Revised 3-11-98

## 135/150 Optimax Update

#### MERCURY/MARINER

S/N 0G636539 Thru S/N 0G692839

#### ITEM # 1 ENGINE OIL RESERVOIR – S/N 0G636539 THRU S/N 0G637527

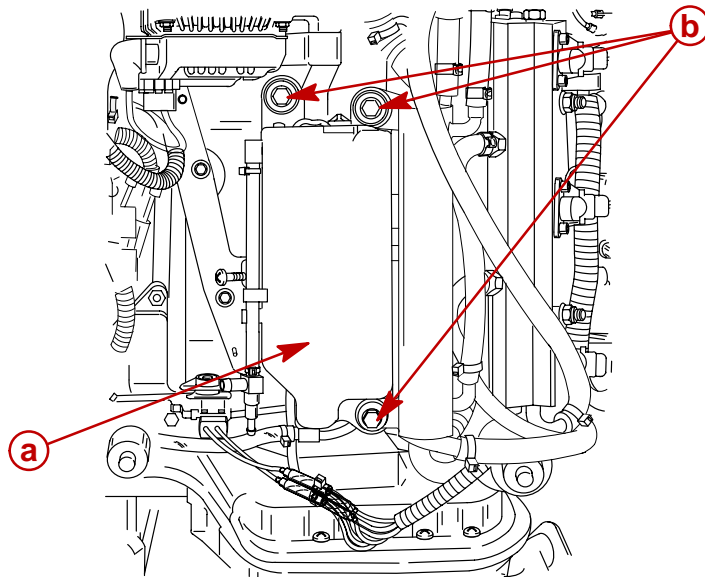
Replace engine oil reservoir to avoid false low oil signals. The replacement engine oil reservoir sensor switch and float, are less sensitive to alternator magnetic field interference. New reservoir P/N 833069A3 includes new sensor and float assembly.

a - Engine Reservoir

b - Bolts (3) [Torque to 170 lb. in. (19.2 N·m)]

**ITEM # 2 OIL PUMP GASKET – S/N 0G636539 THRU 0G654821**

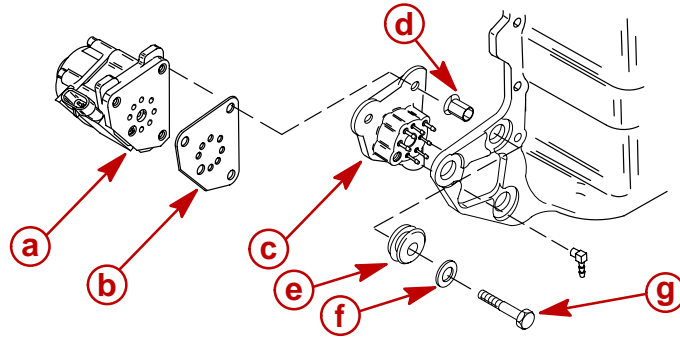
Replace gasket between the oil pump and oil pump bracket. New gasket P/N 27-856542 1 has improved sealing capabilities. New gasket is included in service kit P/N 802707A2.

- a - Oil Pump
- b - Gasket
- c - Bracket
- d - Bushing (3)
- e - Rubber Grommet (3) – Insert into Hole
- f - Washer (3)
- g - Bolt (3) – Torque to 16 lb. ft. (22.0 N·m)

**ITEM # 3 OIL HOSES – S/N 0G636539 THRU 0G692839**

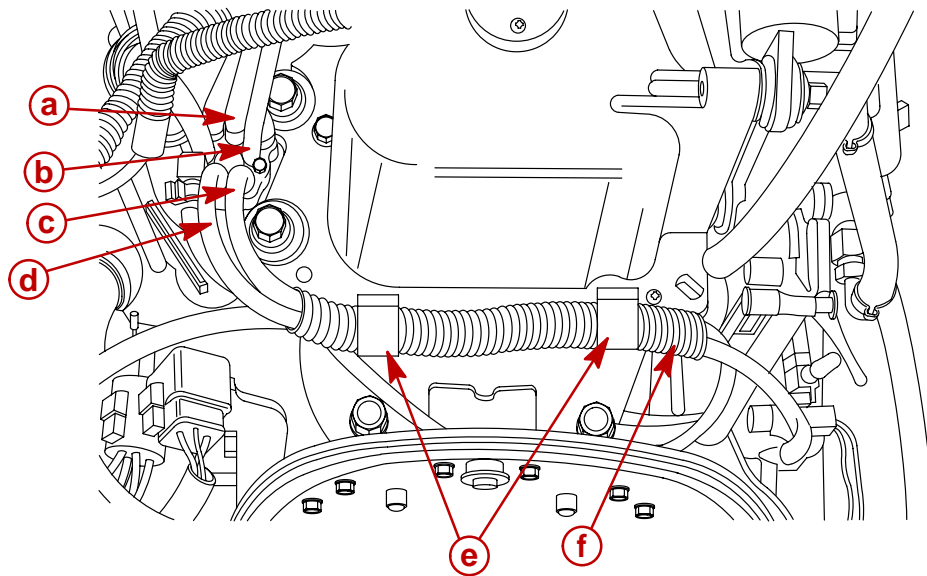
Replace the four smaller diameter oil hoses that supply oil to the port side cylinders, and air compressor. New hoses are made of an improved material. Four 28-1/2 in. hoses will be supplied in the kit, three must be cut to length. Route hoses as shown below, using conduit and clamps supplied with kit P/N 802707A2.

- a - Oil Hose Air Compressor
- b - # 2 Cylinder
- c - # 4 Cylinder
- d - # 6 Cylinder
- e - New "J" Clamps, Torque Clamp Retainer Bolts to 100 lb. in. (12.0 N·m)
- f - Conduit Supplied with Kit

**NOTE:** When oil reservoir, oil pump gasket, or oil hoses are changed, the oil pump priming procedure must be performed. Refer to section 3C-4 of the 135/150 Direct Fuel Injection Service Manual (P/N 90-855347) for correct procedure.

**ITEM # 4 STARTER MOTOR – S/N 0G636539 THRU 0G638551**

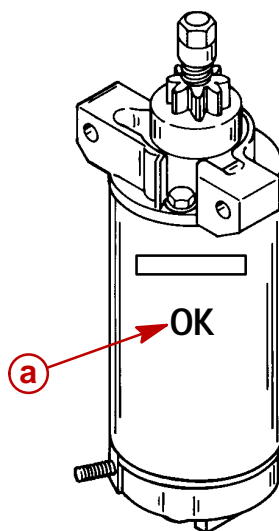
The rubber snubber inside the motor housing may have been, dislodged during assembly. Inspect engine carton, or starter motor for having been reworked at the factory. Rework identification listed below. If engine has **NOT** been reworked at the factory, replace the starter motor with **P/N 50-833153 2**.

**FACTORY REWORK:** Engines reworked at the factory will have a Blue dot marked on the engine carton near the serial number location, and the white letters "OK" marked on the starter motor near the part number label.

**DEALER REWORK:** Mark the replacement starter motor with the white letters "OK" near the part number label.

a - Factory rework marking (OK)

**ITEM # 5 FUEL HOSE – S/N 0G636539 THRU 0G666068**

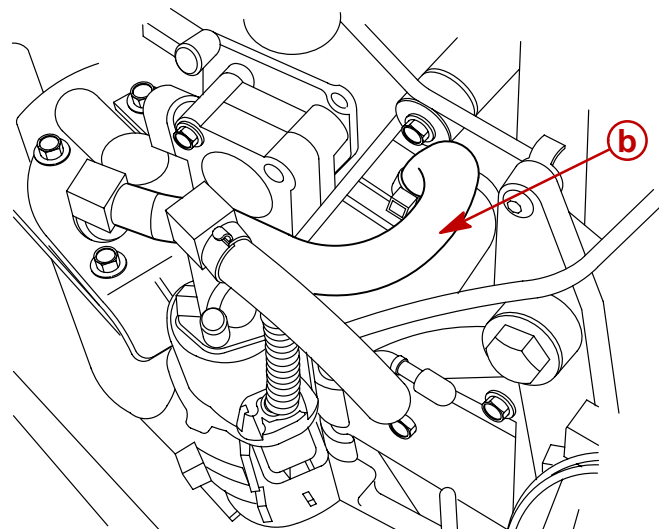
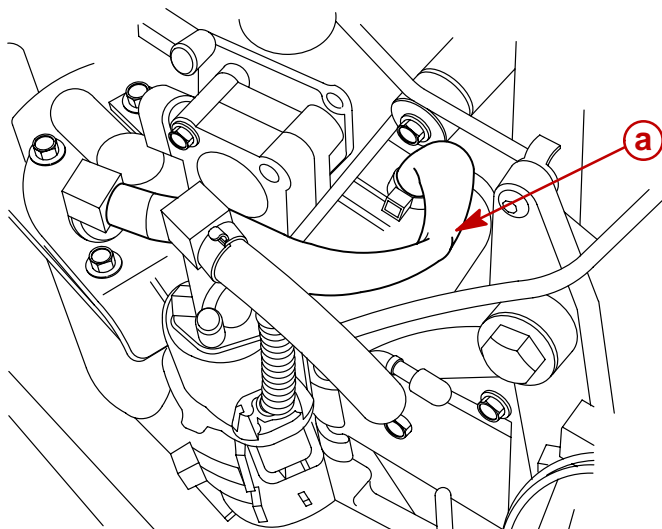
The pulse fuel pump hose to the vapor separator tank (VST) could have a partial kink at the formed bend. Inspect hose and shorten at the VST end to remove kink. The amount of hose removed may vary between 3/8 in. to 1/2 in.

a - Fuel hose with kink  
b - Fuel hose with correct contour (no kink)

**ITEM # 6 AIR PRESSURE HOSE – S/N 0G636539 THRU 0G665930**

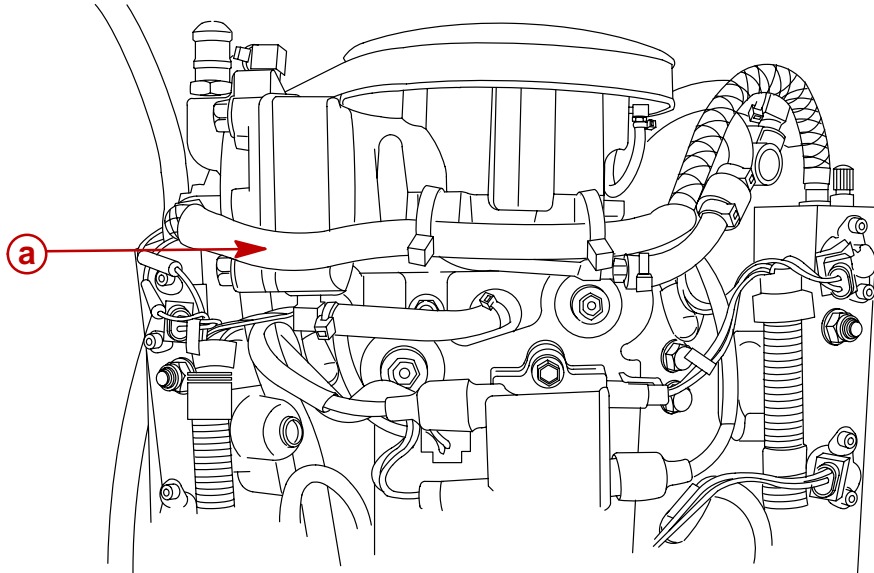
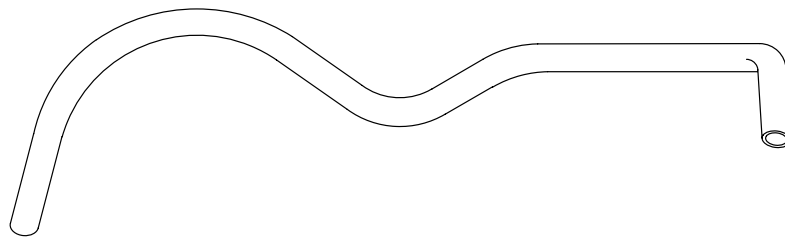
Replace the air compressor output hose. This new formed hose has improved alignment with the fitting on compressor and fuel rail. Engines that have been reworked at the factory, have a GREEN dot marked on the engine carton near the serial number.

New air pressure hose P/N 32-850251 1 and metal clamps are included in kit P/N 802707A2.

a - Air pressure hose

**ITEM # 7 FUEL RAIL PART NUMBER LABEL – S/N 0G670200 THRU S/N 0G681161**

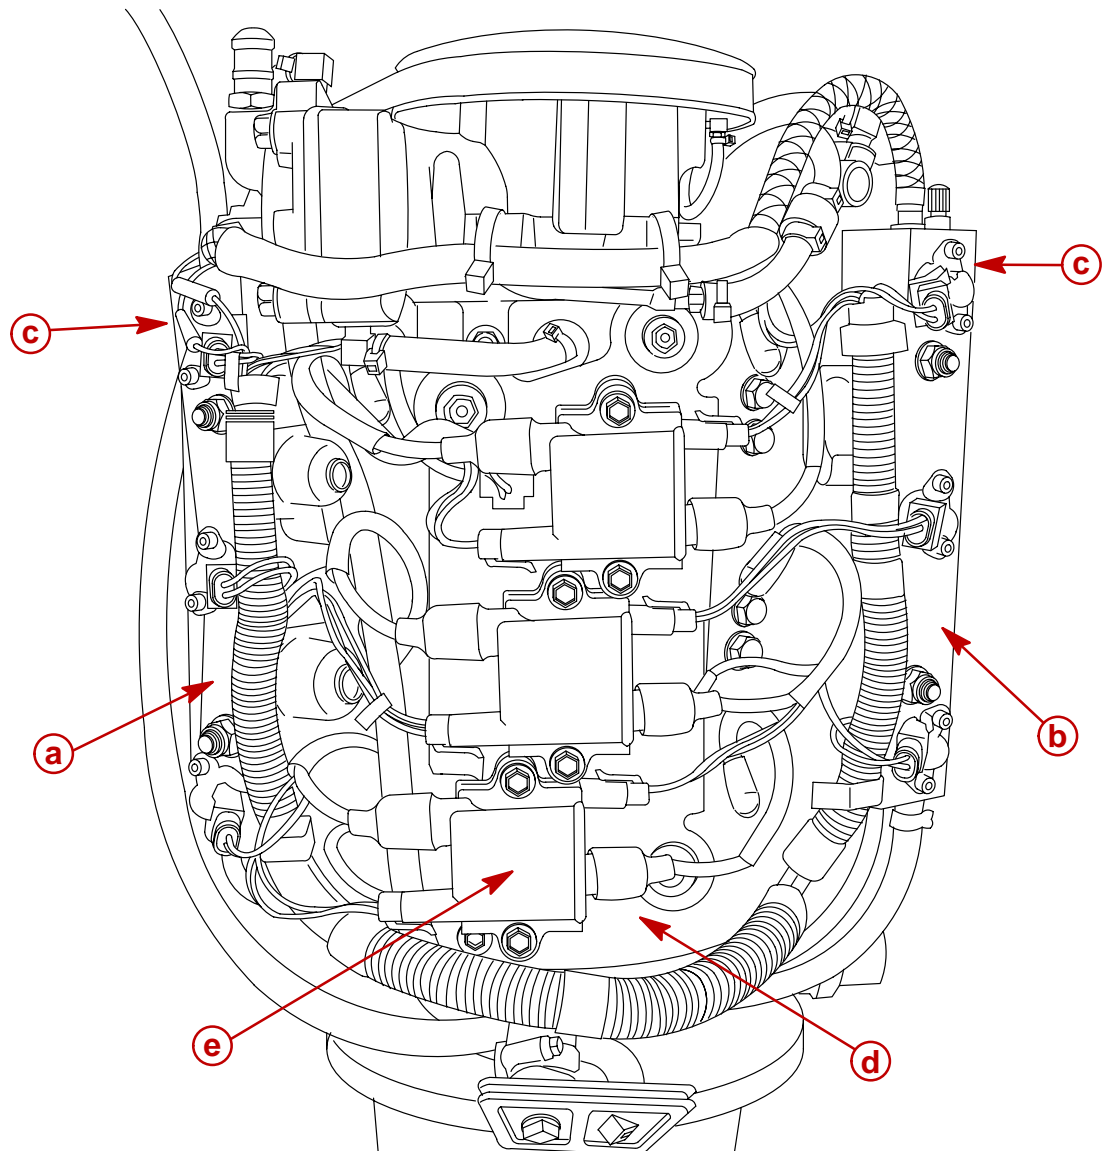
The fuel rails are identified with part number labels. The starboard fuel rail between serial numbers listed above may have incorrect labels. Part number labels on engine components should not be used when ordering part. To eliminate any confusion, check for the correct part number label on the starboard fuel rail. If the label is incorrect, remove and discard, replacement label is not required.

**Incorrect part number**      **852378A4**  
**Correct part number**        **852379A4**

**ITEM # 8 SPARK PLUG BOOTS – S/N 0G636539 THRU S/N 0G681161**

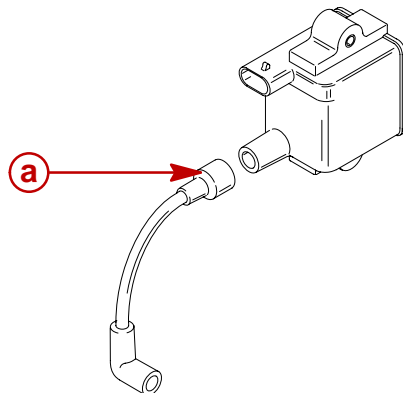
The boot on the ignition coil high voltage tower may become loose, allowing contaminants to enter. Ignition coils now have the boot glued in place to prevent loosening. Because of the difficulty in cleaning the existing boots and coil towers, to insure good bonding of parts, replace the complete ignition coil plate assembly. For this up-date only order one ignition plate P/N 850675A3 for each outboard. Ignition plate assembly will include all coils, and Hi-tension leads, pre assembled and ready to install.

a - Coil high voltage tower boot

**ITEM # 9 FUEL INJECTOR RETAINER BOLTS – S/N 0G680738 THRU S/N 0G693228**

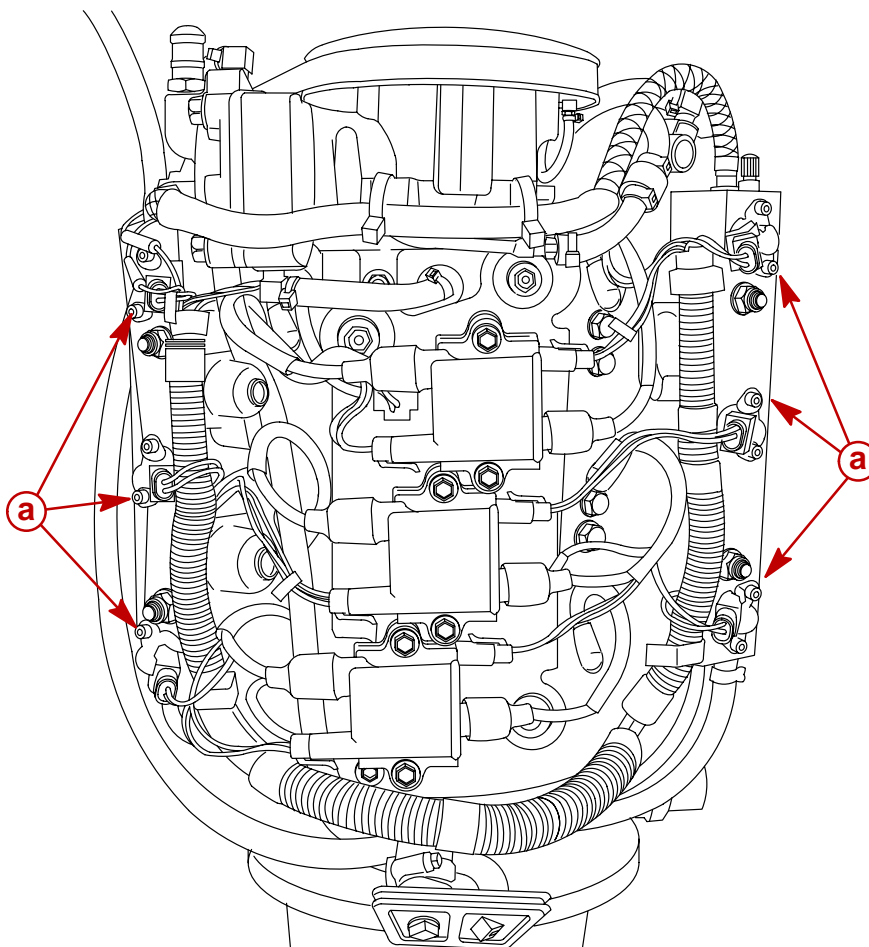
The fuel injector retainer bolts may have been torqued incorrectly. Check the torque of the 12 bolts that retain the 6 fuel injectors. Torque should be 55 in. lbs. (6.2 N·m).

a - Fuel Injector Retainer Bolts (12) – Torque to 55 lb. in. (6.2 N·m)

**ITEM # 10 POWER TRIM PISTON/ROD – S/N 0G653854 THRU 0G681265**

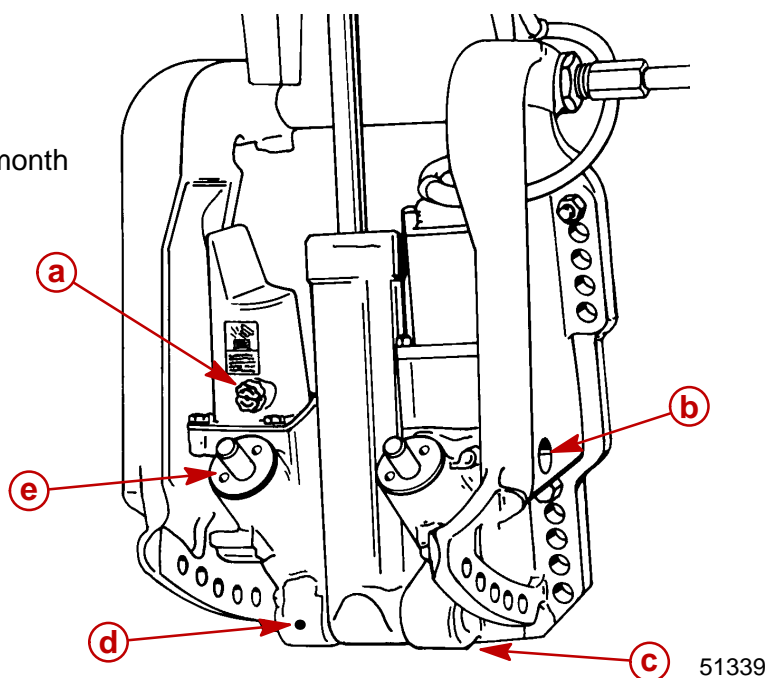
The port side power trim piston/rod assembly may have been incorrectly machined on some of the engines listed. This could cause the tilt relief valve function to become disabled, allowing the engine to trim past the clamp brackets at higher than normal propeller thrust.

Any engine that **DOES NOT** have the factory rework marking, should have the anode assembly removed from the power trim, to inspect for affected date codes. Affected date codes are 7I02 thru 7K07. Power trims with date codes that are not in the affected range do not require trim piston/rod replacement.

- A white paint dot on the port side of the trim manifold near the tilt cylinder lower cross pin area.
- Engine carton will have a **ORANGE** dot near the serial number location.

- a - Fill cap  
 b - Manual valve  
 c - Date code location  
 d - Factory rework mark (white dot)  
 e - Port trim ram
